Process Sheet

Customer : CU-DAR001 Dart Helicopters Services	Drawing Name : GASKET
Job Number : 36419	
Estimate Number : 12903	
P.O. Number : <i>N/A</i>	Part Number : D355811
This Issue : 12/18/2007 S.O. No. : <i>N/A</i>	Drawing Number : D3558 REV B
Prsht Rev. : NC	Project Number : N/A
First Issue : 12/18/2007 Type : SMALL /MED FAB	Drawing Revision : B
Previous Run : 33014	Material : <i>N/A</i>
Written By : _____	Due Date : 1/20/2008 Qty: 10 Um: Each
Checked & Approved By : <i>AS 07-12-18</i>	
Comment : Est Rev:A New Issue 07.06.12 EC	
Est Rev:B Rev B dwg 07-12-06 DD

DART AEROSPACE USA, INC
PORT HADLOCK, WA
DRAWING NO. D3558
TITLE GASKET
REV. B
SHEET 1 OF 1
SCALE 1:8
COPYRIGHT © 2007 BY DART AEROSPACE USA, INC
THIS DOCUMENT IS PRIVATE AND CONFIDENTIAL AND IS SUPPLIED ON THE EXPRESS CONDITION THAT IT IS NOT TO BE USED FOR ANY PURPOSE OR COPIED OR COMMUNICATED TO ANY OTHER PERSON WITHOUT WRITTEN PERMISSION FROM DART AEROSPACE USA, INC.

D3558-13 GASKET

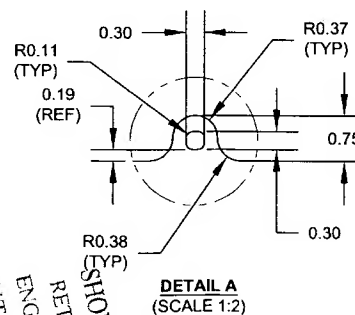
W/O:		WORK ORDER CHANGES					
DATE	STEP	PROCEDURE CHANGE	By	Date	Qty	Approval Chief Eng / Prod Mgr	Approval QC Inspector
07.12.20	3.0	TYPO FOR HOLE PITCH D3552-11. SHOWN

NCR:		WORK ORDER NON-CONFORMANCE (NCR)						
DATE	STEP	Description of NC Section A	Corrective Action Section B			Verification Section C	Approval Chief Eng	Approval QC Inspector
			Initial Chief Eng	Action Description Chief Eng	Sign & Date			
07.12.20	3.0	TYPO FOR HOLE PITCH ON D3552-11 R.C. Humman error	PH per QSS 042 07.12.20	DRAWING SHOULD READ 5.63" AS PITCH ACCEPTABLE DEVIATION.	PH per QSS 042 07.12.20	→		7/12/20
